## Comment Deadline: October 8, 2017

### ASHRAE (American Society of Heating, Refrigerating and Air-Conditioning Engineers, Inc.)

BSR/ASHRAE Addendum 62.1b-201x, Ventilation for Acceptable Indoor Air Quality (addenda to ANSI/ASHRAE Standard 62.1-2016)

BSR/ASHRAE Addendum 62.1d-201x, Ventilation for Acceptable Indoor Air Quality (addenda to ANSI/ASHRAE Standard 62.1-2016)

**FIGURE D-1 Two-chamber model.**

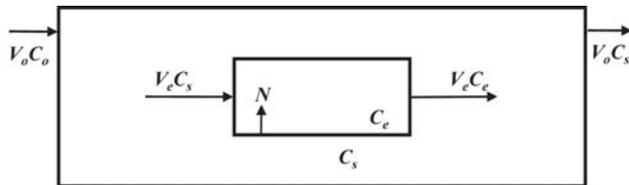
*Delete Informative Appendix D. For legibility, the text is not shown in strikethrough. All text and tables below will be deleted by this proposed addendum.*
